Flamingo Fashions Ltd.(Unit-2)

Mariali, Joydebpur, Gazipur
(24.009385N, 90.415008E)
23rd February 2017

Observations

Typical Floor Beam layout Plan

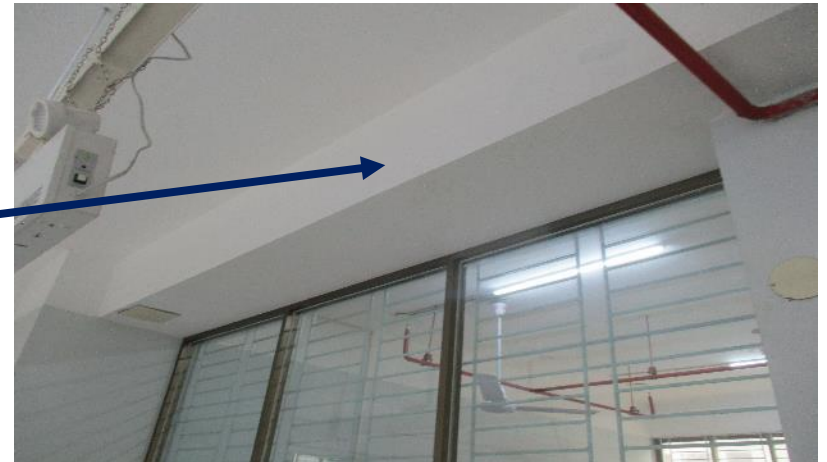
Discrepancies between drawing provided and the as-constructed building

During inspection, Beam of the highlighted area found over sized. Beam width found 24 inch instead of 12 inch on almost every floor.

Prepared Load Plan required to be verified

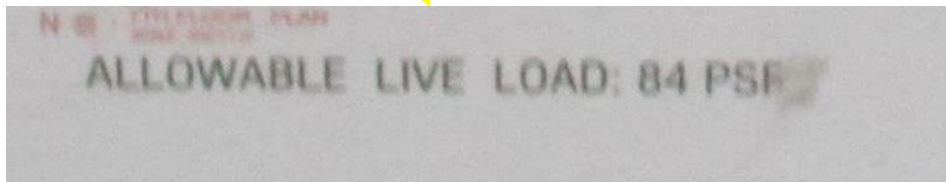
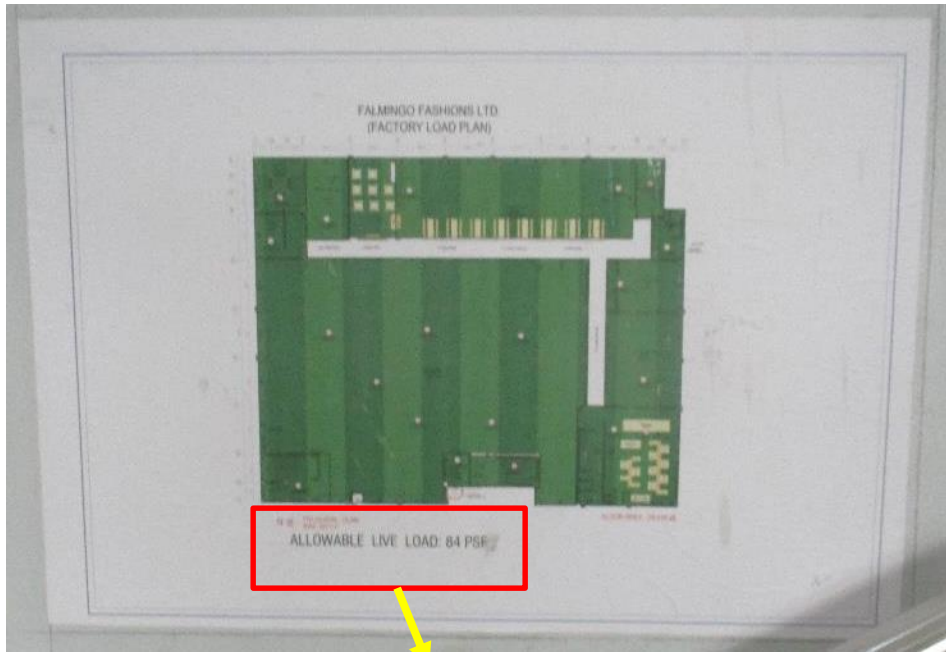
Factory Engineer prepared a load plan considering 4 Kpa (84 psf) allowable floor loading for production building. Design review required if the factory management wants to implement that load plan

Factory is required to maintain floor live load 3Kpa until further verification by design engineer. During inspection, no overloading was observed and FOS calculation for internal column was found satisfactory considering 3Kpa allowable live loading.
